FINAL DRAINAGE PLAN SF 22-001

SKYLINE AT LORSON RANCH

**DECEMBER, 2021
REV MARCH 1, 2022**

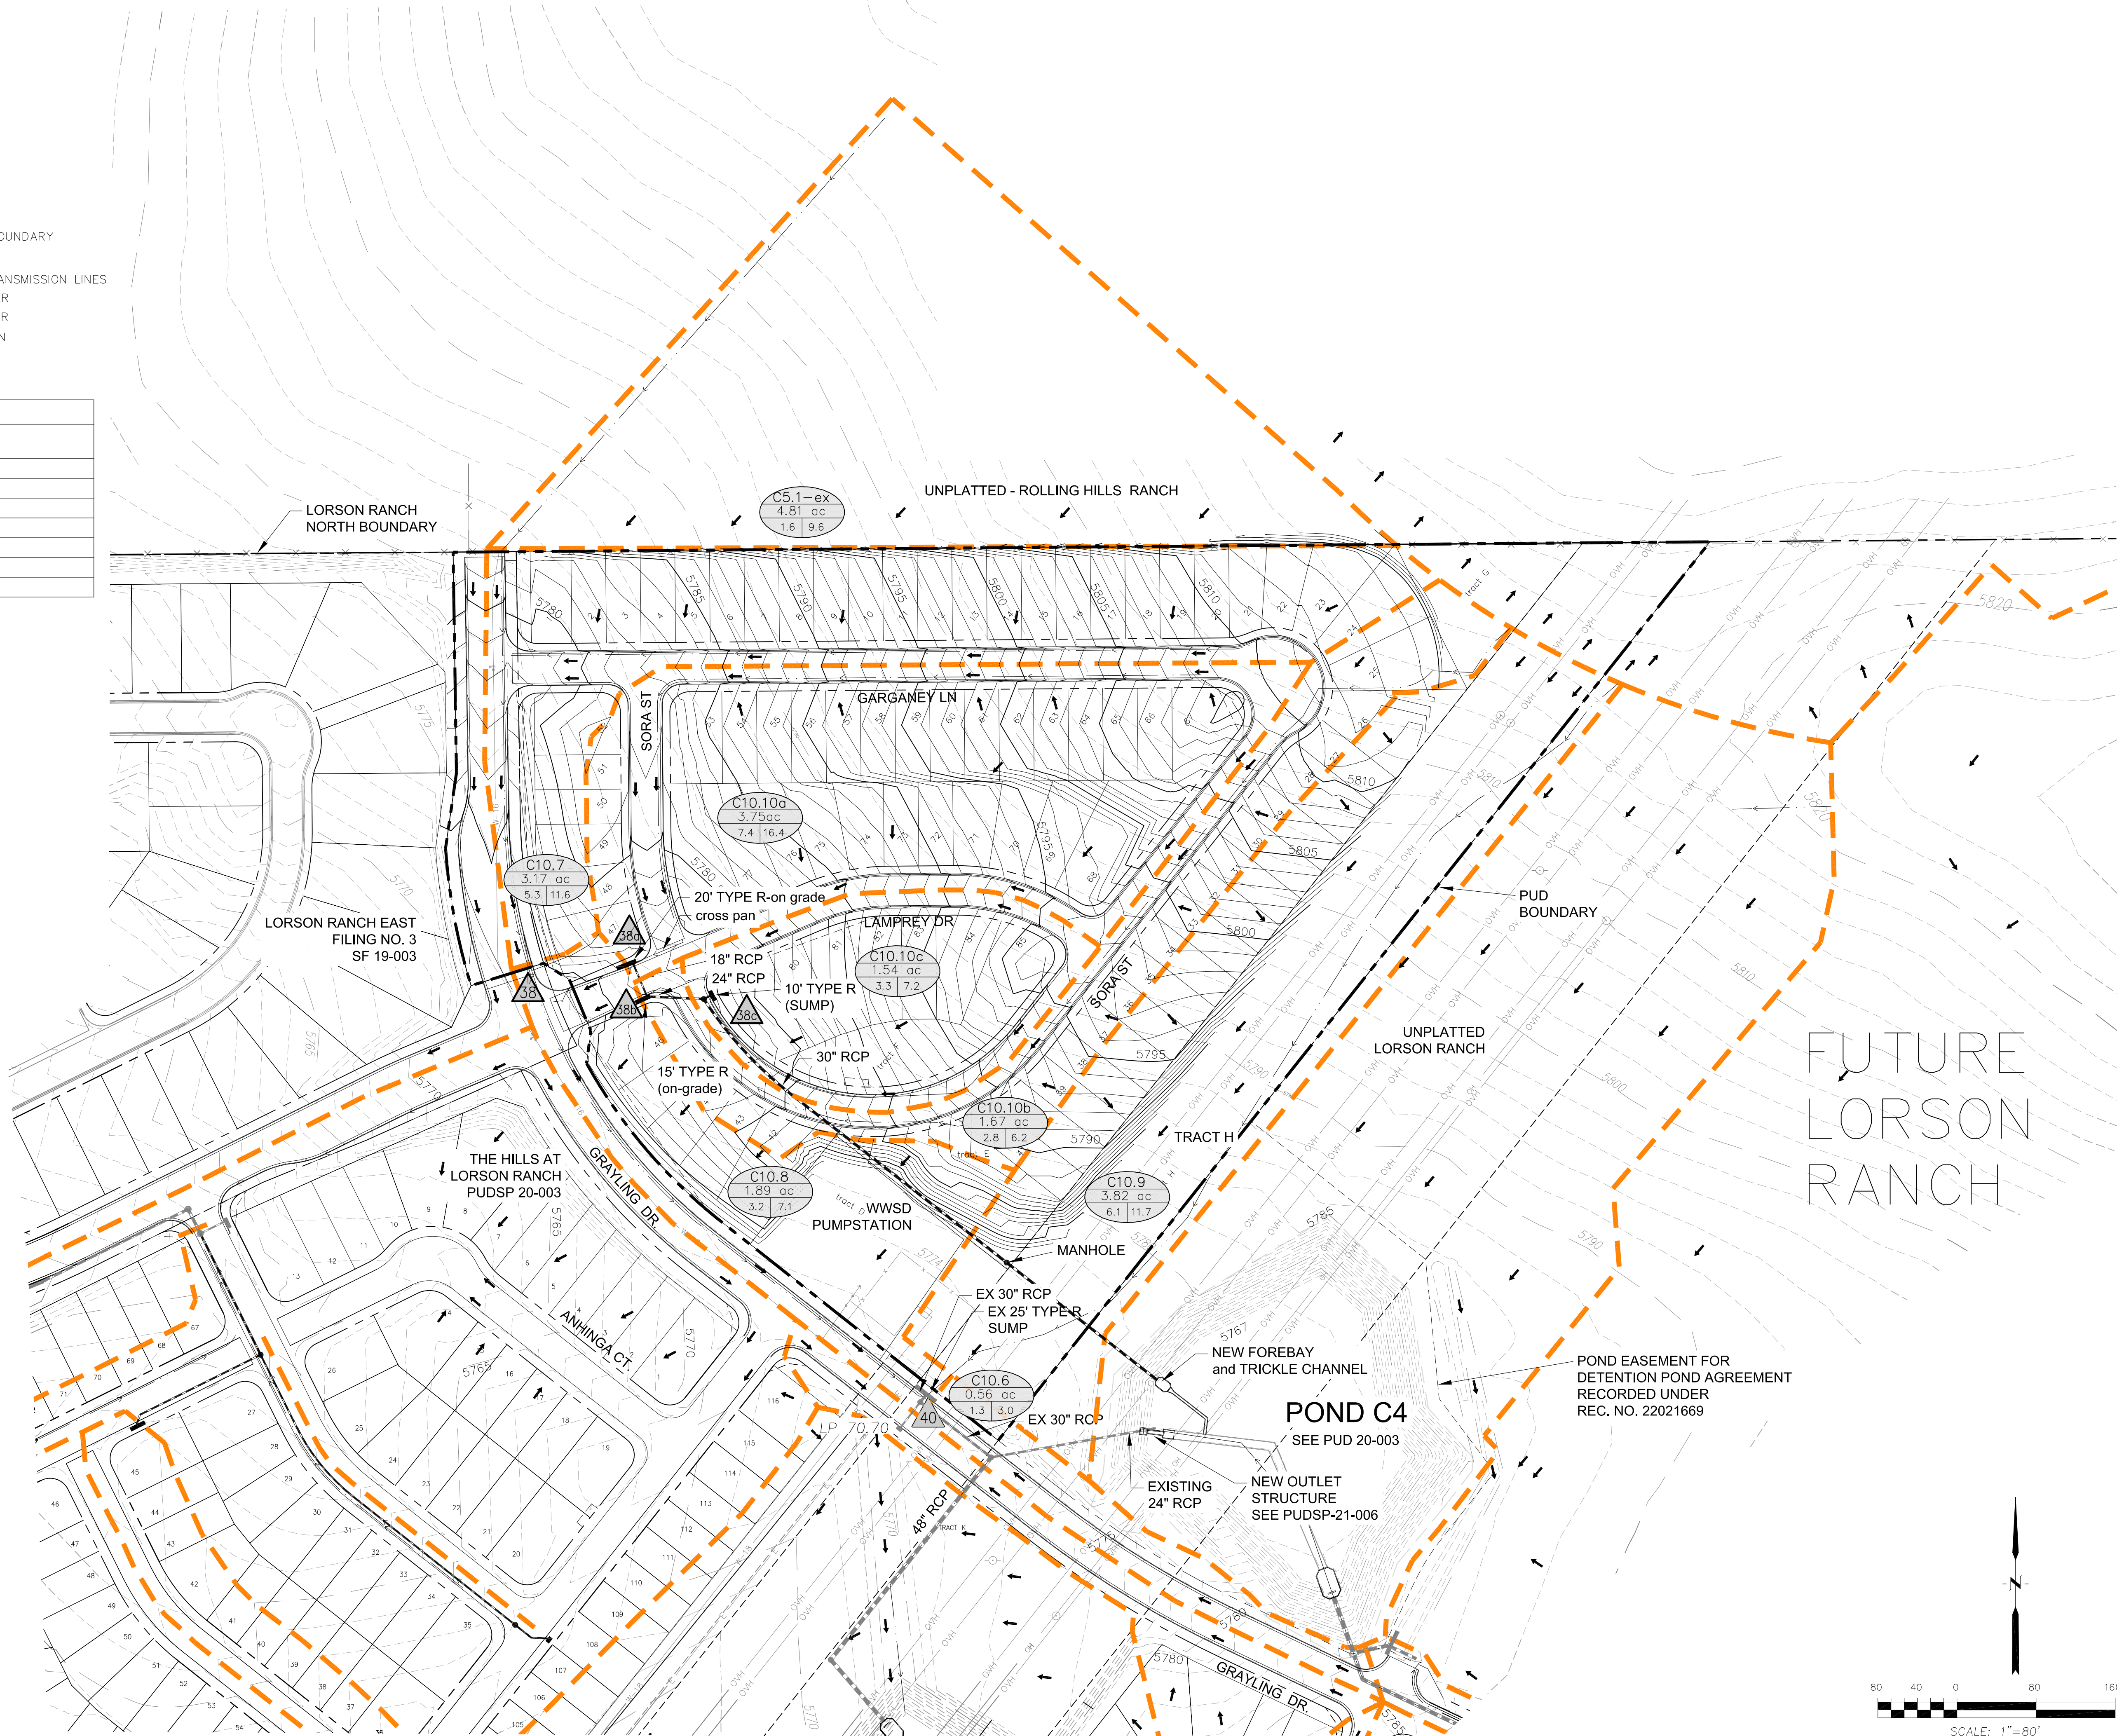
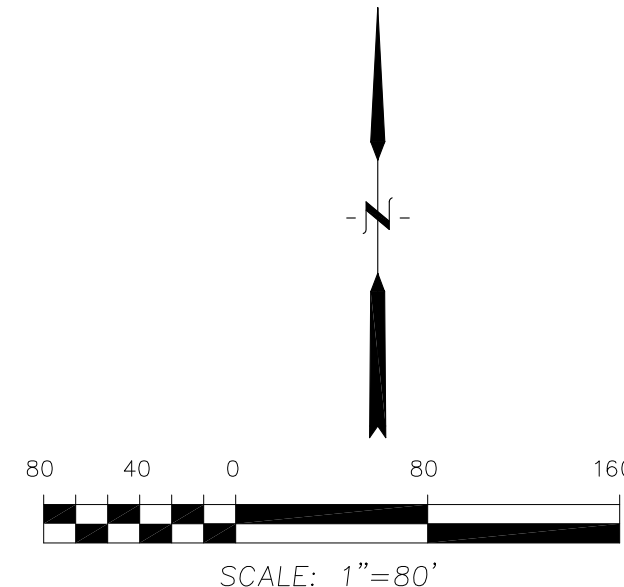
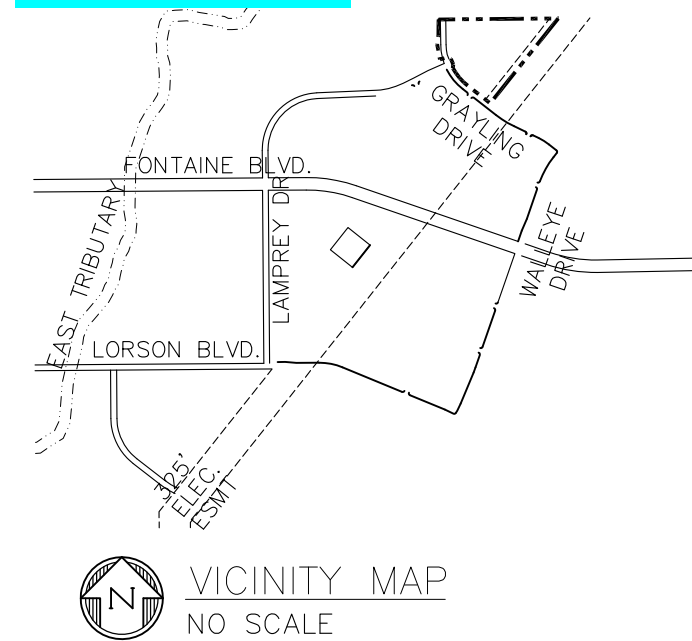
Area for 38b & 38c should be 1.62 & 1.54 acres.
